No: 97117-196
Subject: Primaax Main Beam – Cross Tube
End Cap Connection
Date: July – 2008 Revision A

Reference A: Hendrickson Primaax Technical Bulletin 97117-109 of April 2008

Figure 1.

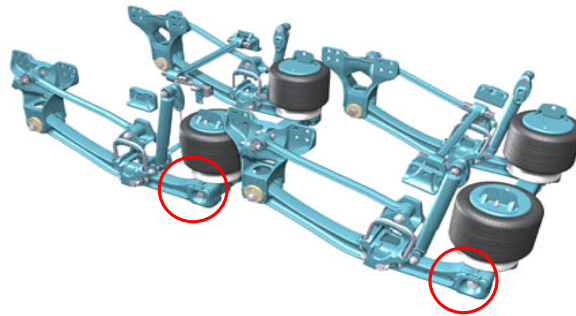
Hendrickson Asia Pacific investigations have revealed that there have been instances of incorrect torque applied to the Primaax Suspension Main Beam and Cross Tube end cap bolts, highlighted at Figure One. Insufficient torque applied to the end cap bolt shall result in accelerated degradation of the end cap connection, place excessive load on the main beam, and as a consequence, significant failure of the main beam may occur.

It is recommended that all vehicles fitted with Primaax Suspension are inspected for loose main beam and cross tube end cap bolts when next in Workshop. The correct torque is 710-780 N.m (525 – 575 ft. lbs). If the suspension has been operated with loose hardware connections, it is highly probable that continual loosening of the bolts, even after being re-tensioned to specifications, will occur. Effective repair may require replacement of the main beam, cross tube and fasteners.
